Kenavon Drive

READING

Landscape Comparison Booklet

Date: June 2020 Rev B

Proposed Arrival Square Detail Plan

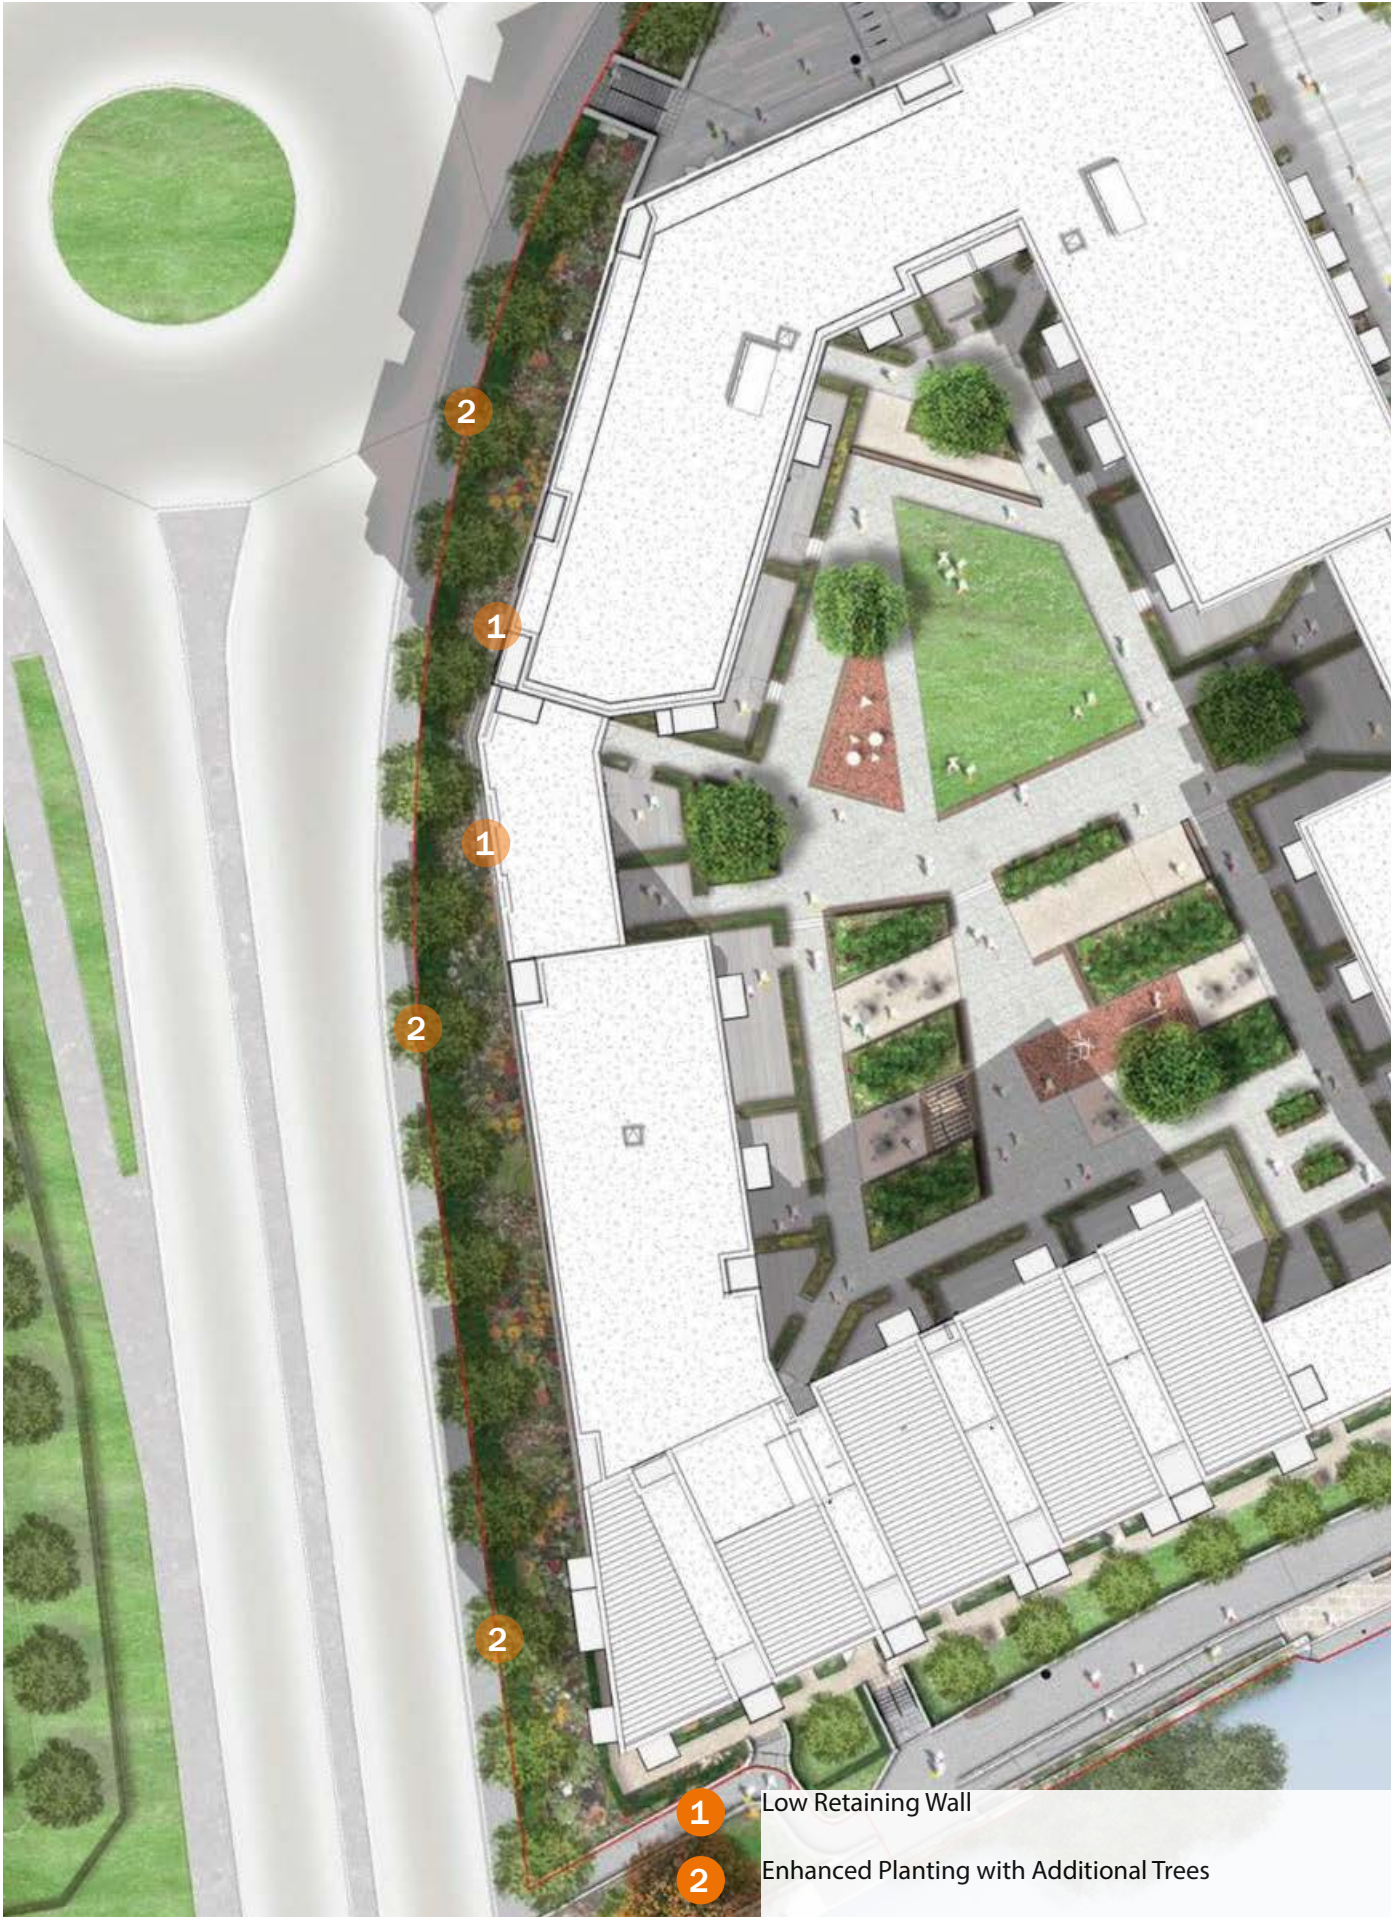
This area remains largely the same. The boundary tree planting include liquidamber trees and a landmark feature oak tree. This provides distinction to the arrival area, but still ensures good visibility from the street into the square.

- 1 Raised Edge
- 2 Landmark feature tree
- 3 Liquid amber street trees
- 4 Pedestrian Crossing

Proposed Forbury Road Edge Detail Plan

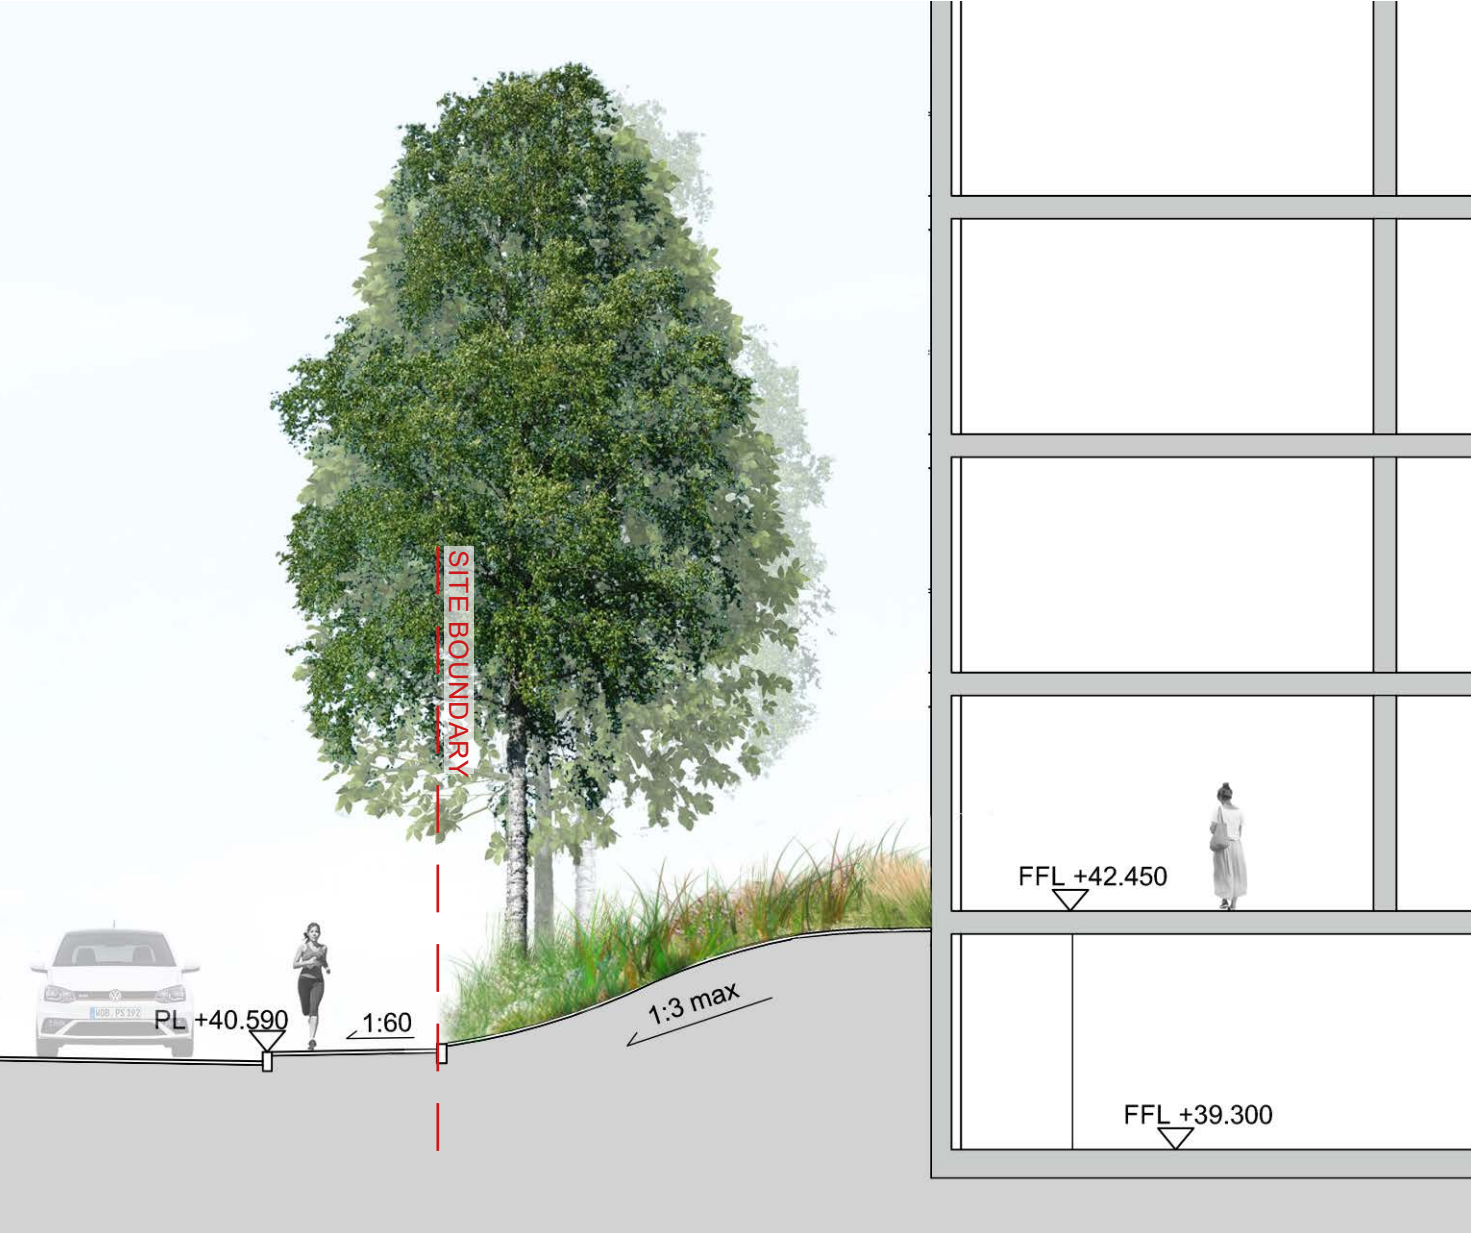
- 1 Low Retaining Wall
- 2 Enhanced Planting with Additional Trees
- 3 French drain

Proposed Huntley Street detail plan

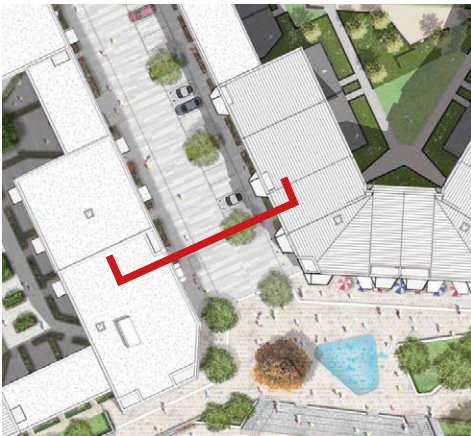
Huntley Street remains similar to planning. Planting beds between parking bays has been extended and trees has been realigned slightly towards the centre of the street.

- 1 Extended Planting Bed
- 2 Planted Frontage
- 3 Integrated Street with Wide Footway

Proposed Mid Block Entrance Detail Plan

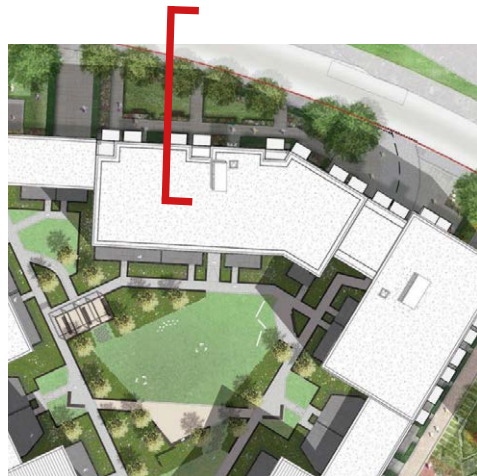
The number of entrances to the properties from Kenavon Drive has been reviewed and reduced. This reduces the impact on existing tree roots to be retained along the boundary and enlarges the area of lawn and planting. This creates a more usable amenity space that has seating and doorstep play features.

- 1 Reduced Number of Pedestrian Entrances
- 2 Lawn with Planting and Seating
- 3 Less Paving in Root Protection Area

Proposed East Block Entrance Detail Plan

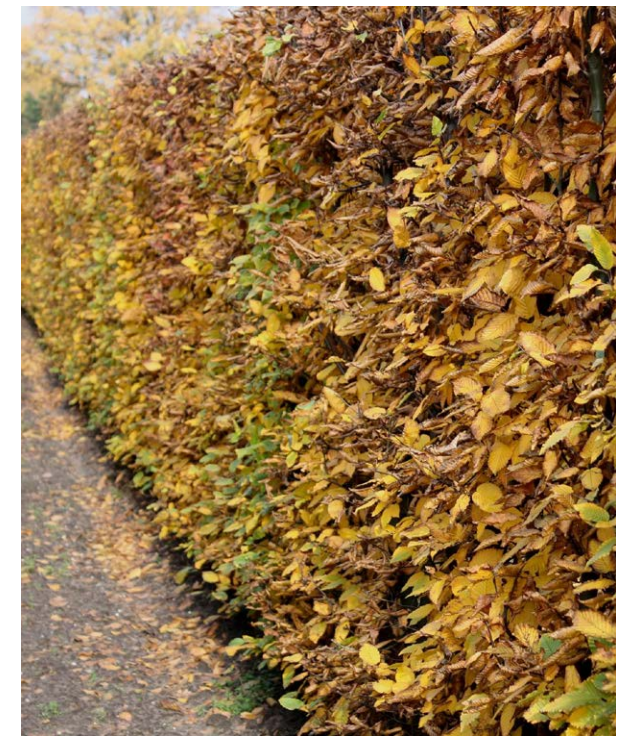
The same approach is continued along the frontage of kenavon Drive, creating a greener, more usable space for residents.

- 1 Fewer Pedestrian Entrances
- 2 Less Paving in Root Protection Area
- 3 Low Planting with doorstep play

Proposed Palmers Street Detail Plan

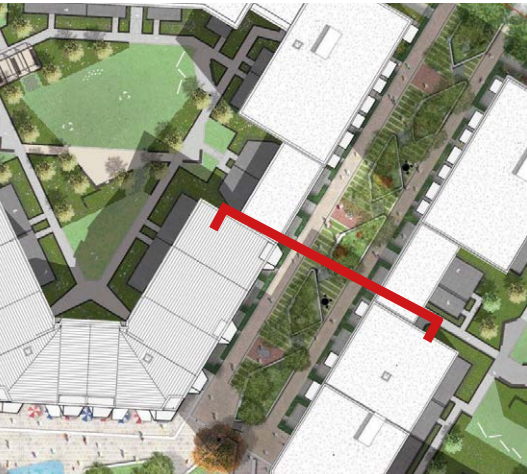
This green street is virtually unchanged, with only minor alterations to the layout and levels to ensure that it is buildable.

1 Level Change Amended

Proposed Jopling Mews

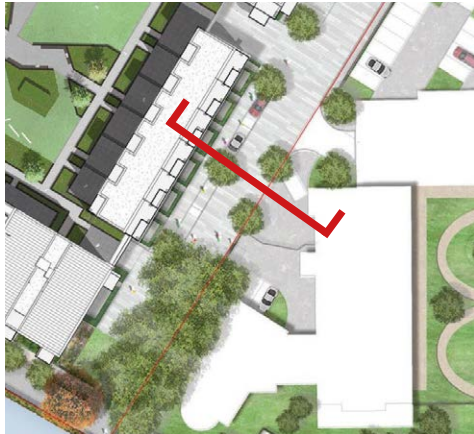
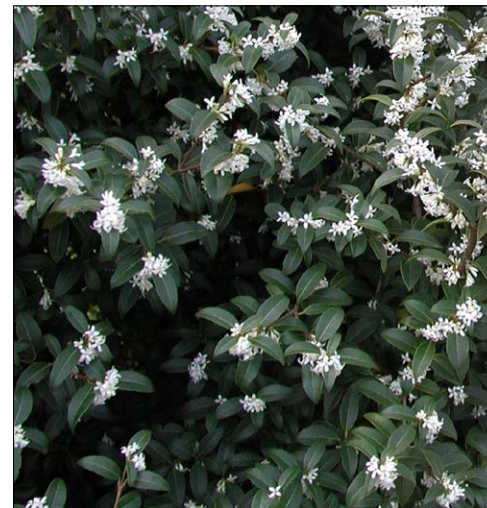
The layout of this street is largely unchanged with the proposal to enhance the boundary through the inclusion of additional trees. The addition of trees next to the boundary helps visually soften this edge and reinforces the public realm character of the route encouraging slow movement of vehicles.

- 1 Reconsidered surface treatment
- 2 Trees introduced to boundary

Proposed West Block River Front Detail Plan

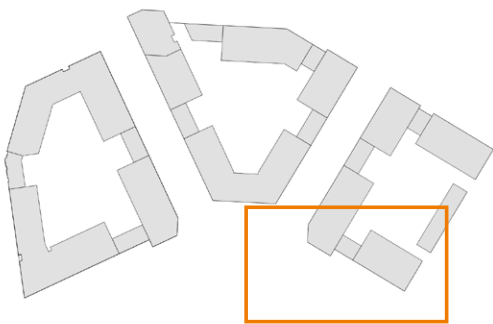
The planting area has been extended to the boundary of Public Right of Way and additional planting has also been included along the base existing wall. These changes will enhance the green character of this riverside walk.

Proposed East Block River Front Detail Plan

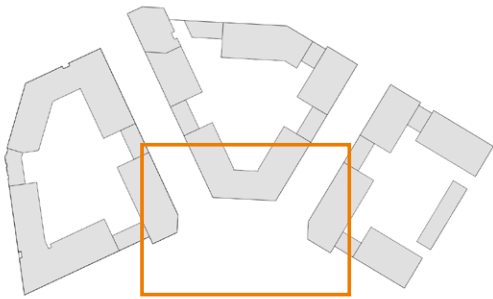
This area has changed very little, with the planting line being moved slightly to accord with the Public Right of Way boundary.

Proposed Mid Block River Front Detail Plan

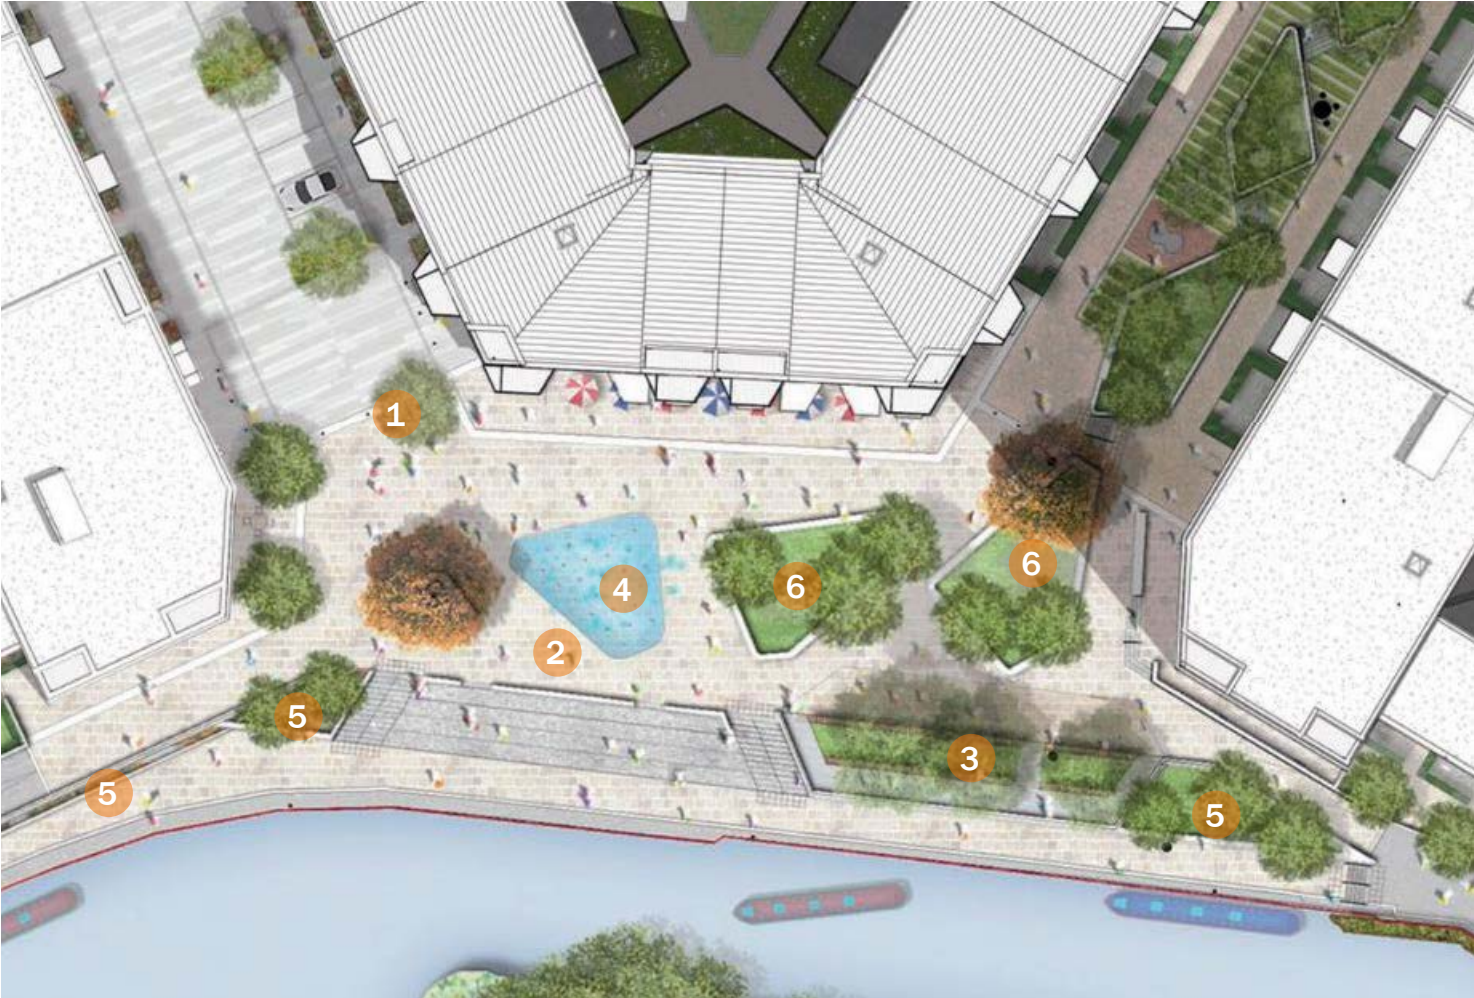
The riverside square has largely as the approved scheme. There have been only minor changes to introduce more greenery to the river frontage. Planting has been introduced underneath the existing retained trees with new associated benches. Planting is also introduced at each end of the terrace and at the lower level along the base of the retaining wall. This provides a greener riverside appearance whilst retaining the amenity, function and geometry of the approved scheme.

- 1 Realigned tree planting
- 2 Terrace space
- 3 Planting encompasses existing trees with associated seating
- 4 Water feature
- 5 Planting Introduced to Lower Tow Path Level
- 6 Raised lawns with seating edge

Proposed East Block Podium

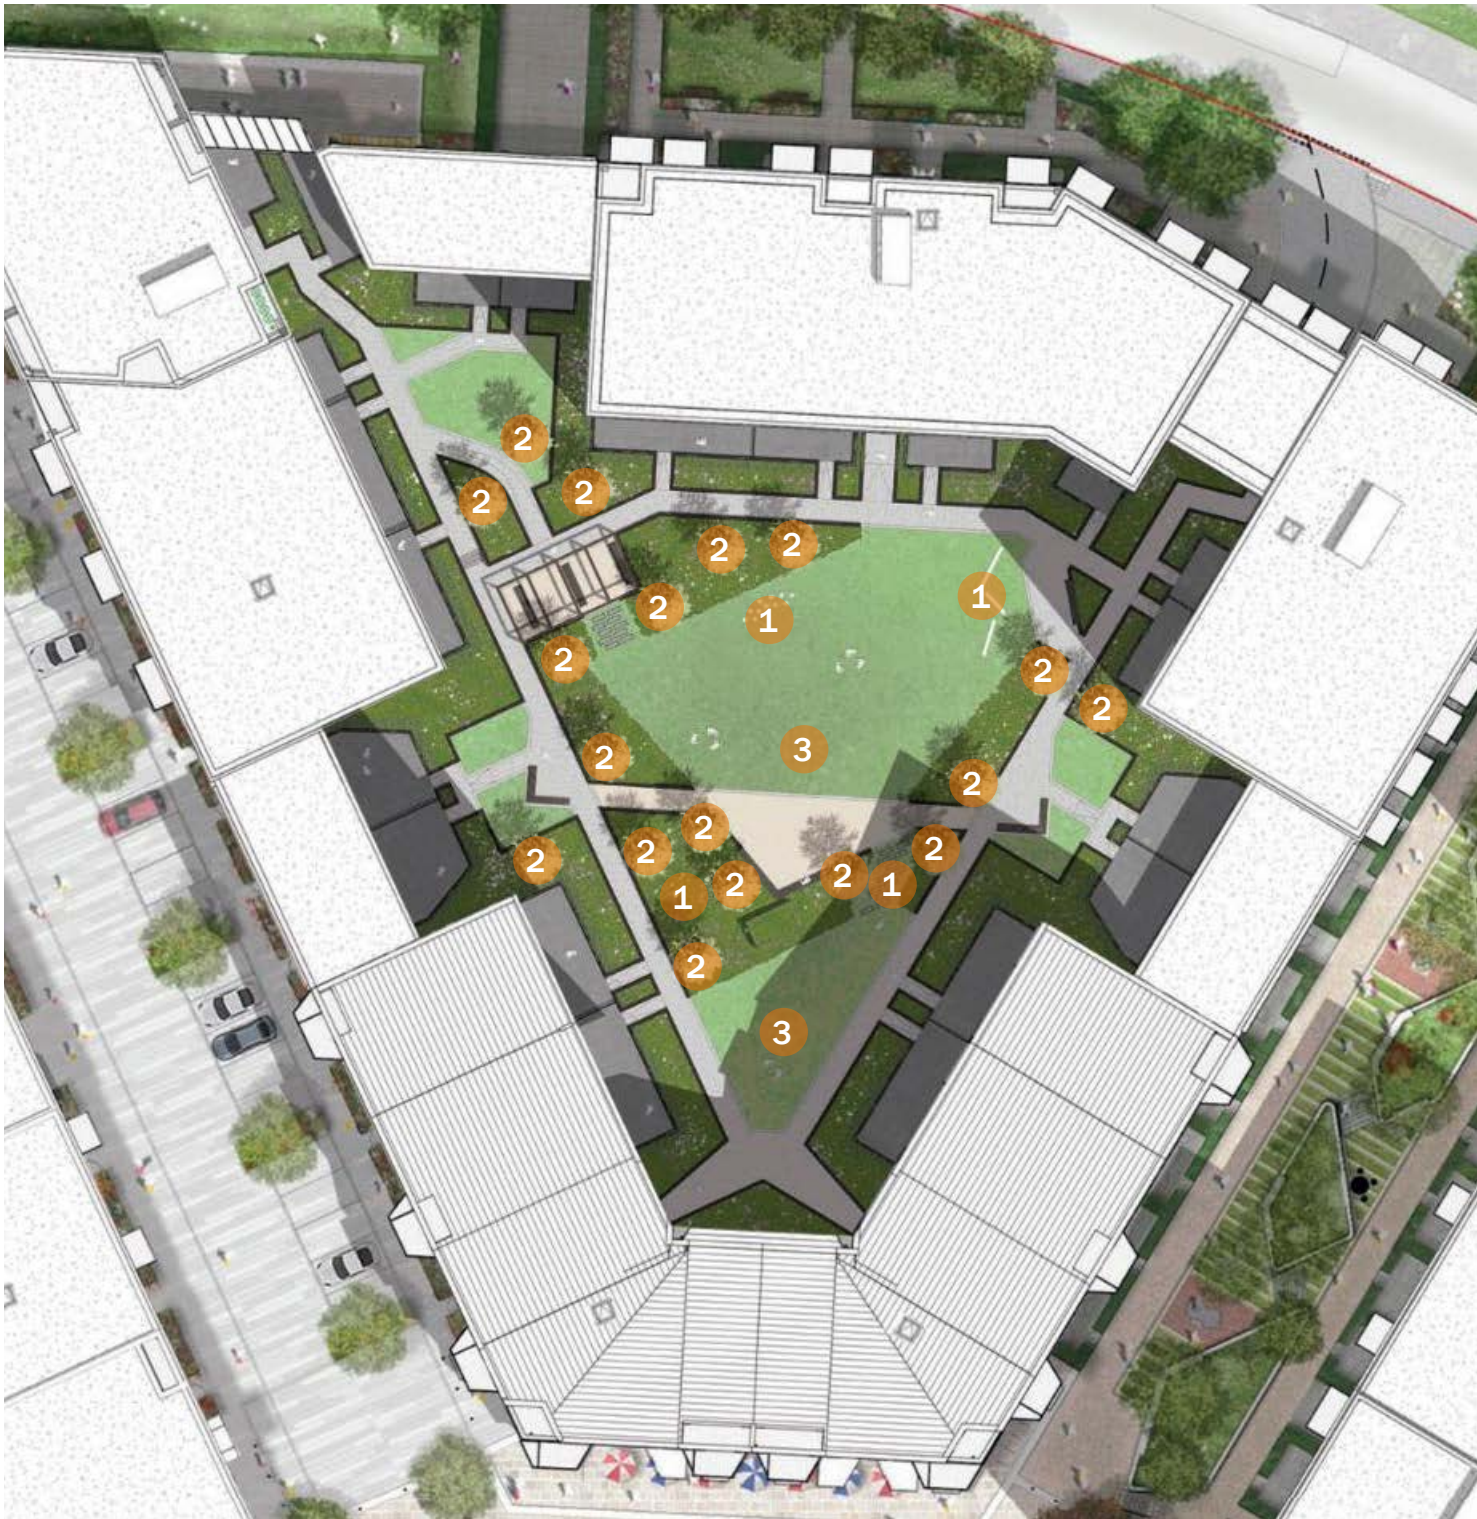
The East Block Podium proposal remains similar to that approved with required rearrangements coming as an offset from adhering to structural requirements and movement routes to comply with fire regulations. Seating areas, a mixture of hard surfaces and soft surfaces spaces reoccur alongside the 2 areas of play and an overall increase in trees and lawn to allow for increased biodiversity and spaces for play and relaxation.

- 1 2 areas of play with cushioned ground finish. The proposal uses artificial turf as finish to help blend in to its surroundings
- 2 Increased quantum of proposed trees from 3 to 9
- 3 Increased areas of lawn for play
